SUBJECT: AMENDMENT NO. 72 TO FACILITY OPERATING LICENSE NO. DPR-22:  
MISCELLANEOUS CHANGES (TACS 69146/71517/72861)

NORTHERN STATES POWER COMPANY  
DOCKET NO. 50-263  
MONTICELLO NUCLEAR GENERATING PLANT  
AMENDMENT TO FACILITY OPERATING LICENSE

Amendment No. 72  
License No. DPR-22

SAFETY EVALUATION BY THE OFFICE OF NUCLEAR REACTOR REGULATION  
RELATED TO AMENDMENT NO. 72 TO FACILITY OPERATING LICENSE NO. DPR-22

Figure 3.6.1 Core Beltline Operating Limits Curve Adjustment vs. Fluence

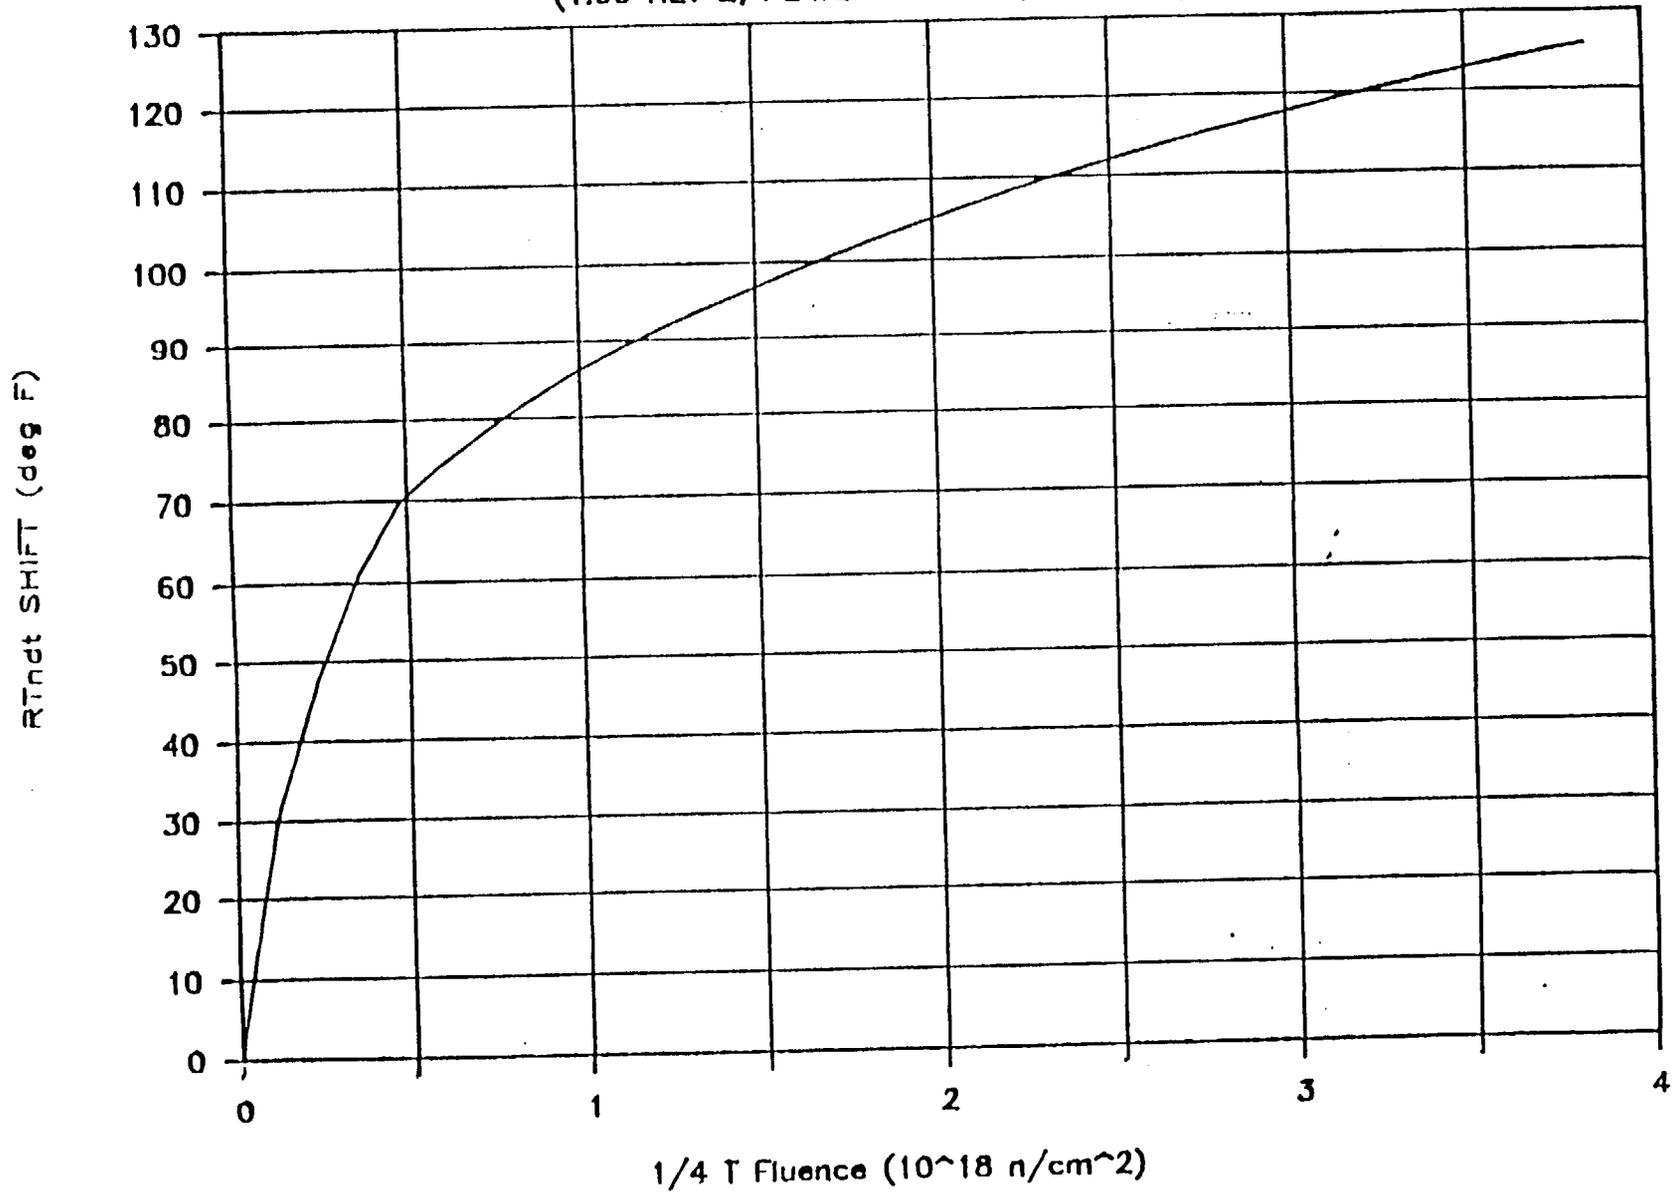
The relationship of predicted adjustment of reference temperature versus fluence and the copper and nickel content of the core beltline materials given in Regulatory Guide 1.99, Revision 2, was used to define the core beltline temperature adjustment versus fluence shown on Figure 3.6.1.

The licensee used the method in RG 1.99, Rev. 2, to calculate an ART of 140 degrees F. for the limiting plate material (I-15) at 32 effective full power years (EFPY) at  $1/4T$  ( $T$ =reactor vessel thickness) in the Monticello beltline. The ART was calculated using Section 1 of RG 1.99, Rev. 2, because only one surveillance capsule has been withdrawn from the Monticello reactor pressure vessel. The NRC staff performed a similar calculation and verified the licensee's ART to be conservative (see Table 1). Substituting the ART of 140 degrees F. into equations in SRP 5.3.2, the staff verified that the proposed P/T limits for heatup, cooldown, and hydrotest meet the beltline material requirements in Appendix G of 10 CFR Part 50.

Figure 3.6.2 Minimum Temperature vs. Pressure for Pressure Tests

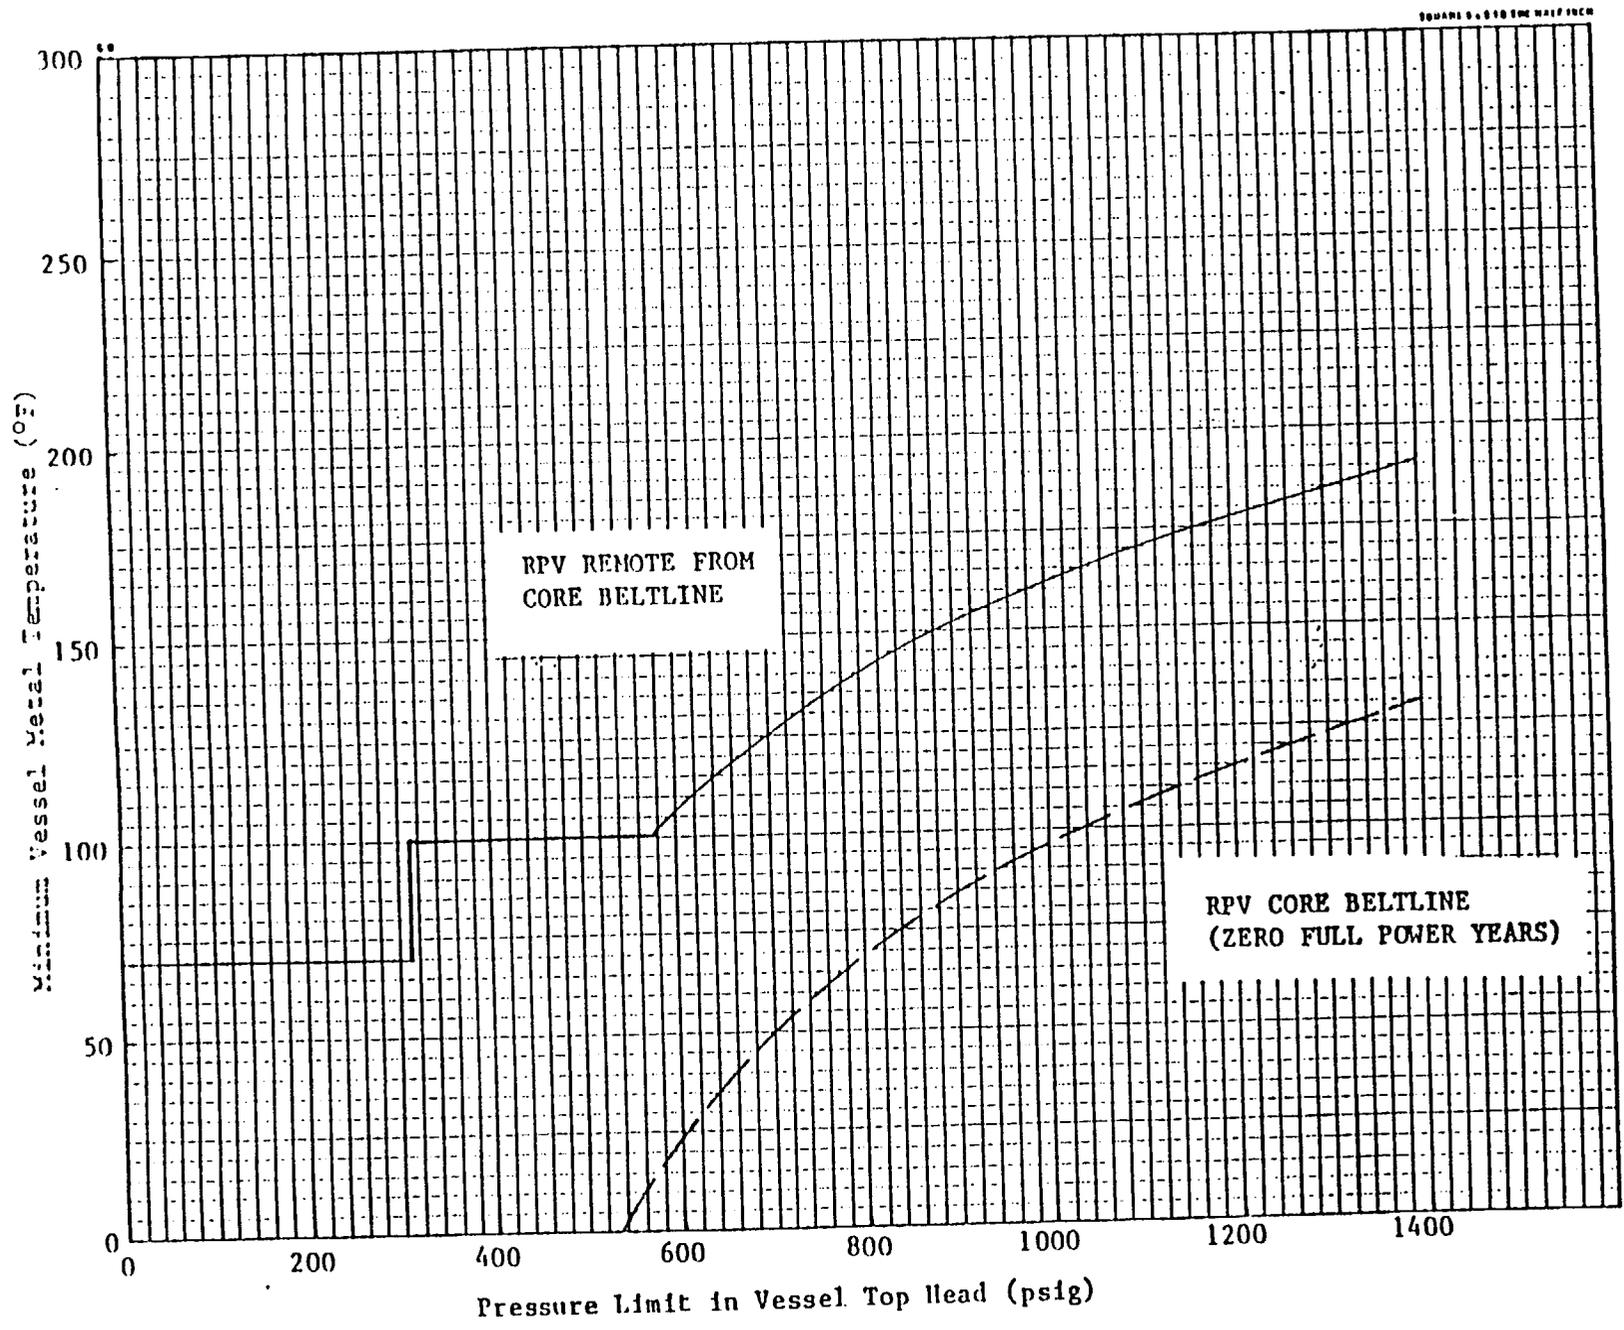
1. During in-service hydrostatic or leak testing, the reactor vessel shell temperatures specified in 4.6.B.1, except for the reactor vessel bottom head, shall be at or above the temperatures shown on the two curves of Figure 3.6.2, where the dashed curve, "RPV Core Beltline," is increased by the core beltline temperature adjustment from Figure 3.6.1. The reactor vessel bottom head temperature shall be at or above the temperatures shown on the solid curve of Figure 3.6.2, "RPV Remote from Core Beltline," with no adjustment from Figure 3.6.1.

In addition to revising the P/T limit curves to meet RG 1.99, Rev. 2 criteria, the licensee also proposes that, during pressure tests, the reactor vessel bottom head temperature be monitored separately from the beltline region. This would facilitate pressure testing by reducing the amount of non-nuclear heatup required for pressure testing. In order for this to be acceptable, it is necessary that operators have the capability to monitor the beltline region temperature separately. The licensee has advised the staff that this capability is provided by redundant resistance temperature detectors (RTDs).

Figure 3.6.3 Minimum Temperature vs. Pressure for Mechanical Heatup or Cooldown Without the Core Critical

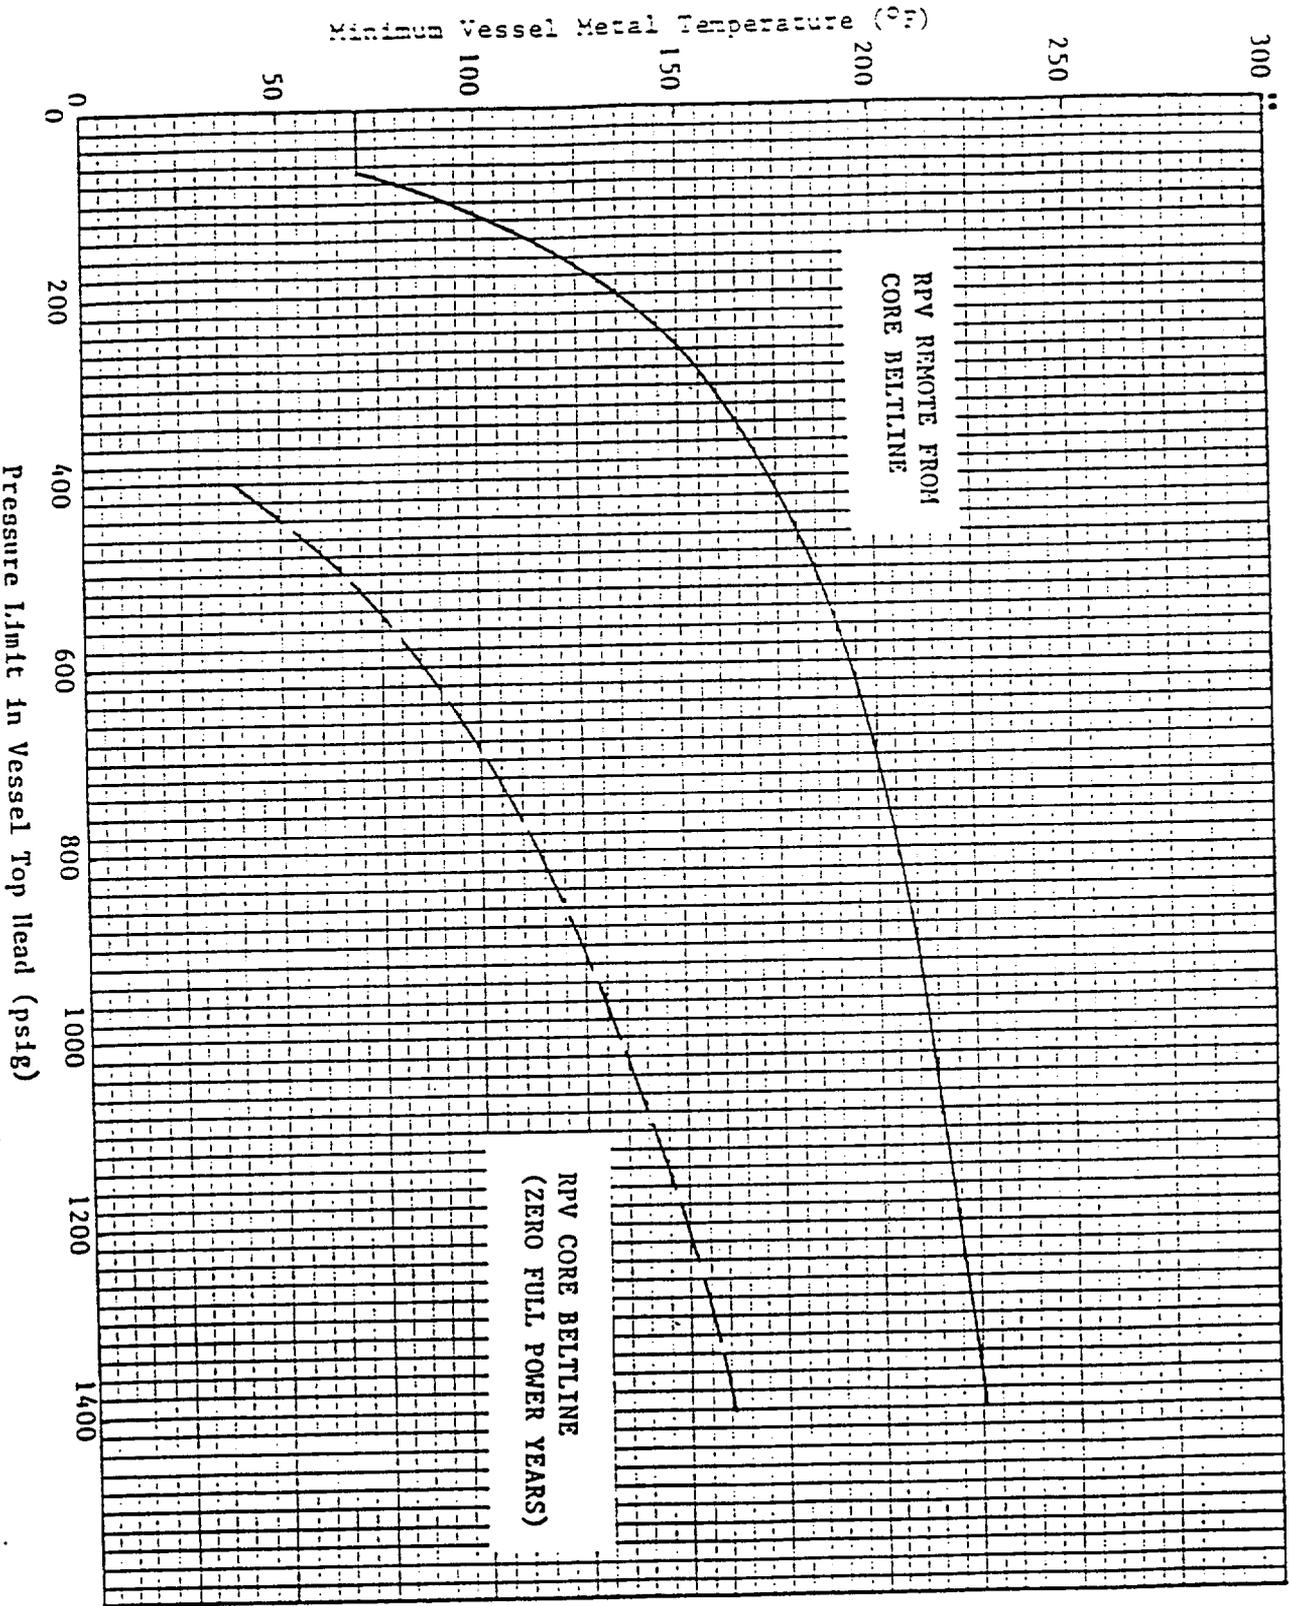
2. During heatup by non-nuclear means (except with the reactor vessel vented), cooldown following nuclear shutdown, or low level physics tests the reactor vessel shell and fluid temperatures specified in 4.6.A shall be at or above the higher of the temperatures of Figure 3.6.3 where the dashed curve, "RPV Core Beltline," is increased by the expected shift in  $RT_{NDT}$  from Figure 3.6.1.

Figure 3.6.4 Minimum Temperature vs. Pressure for Core Operation

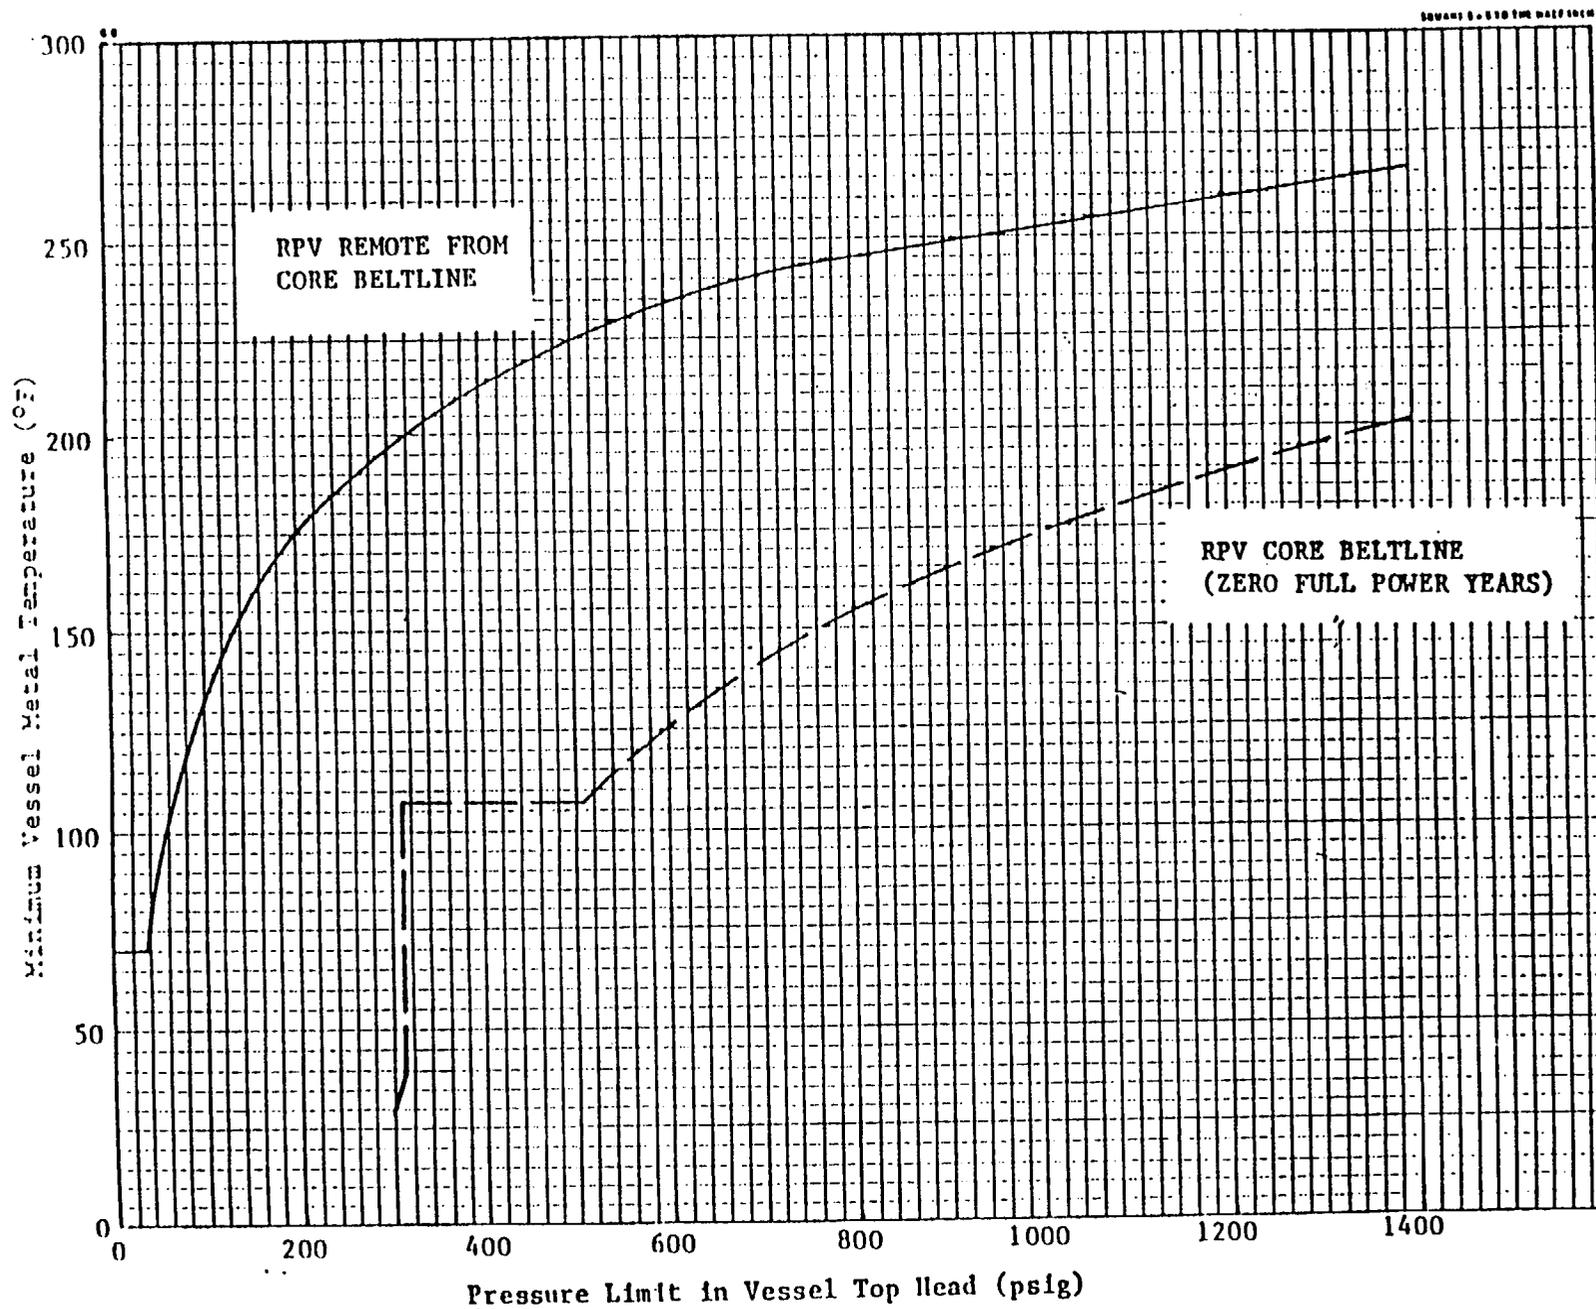
3. During all operation with a critical reactor, other than for low level physics tests or at times when the reactor vessel is vented, the reactor vessel shell and fluid temperatures specified in 4.6.A shall be at or above the higher of the temperatures of Figure 3.6.4 where the dashed curve, "RPV Core Beltline," is increased by the expected shift in  $RT_{NDT}$  from Figure 3.6.1.
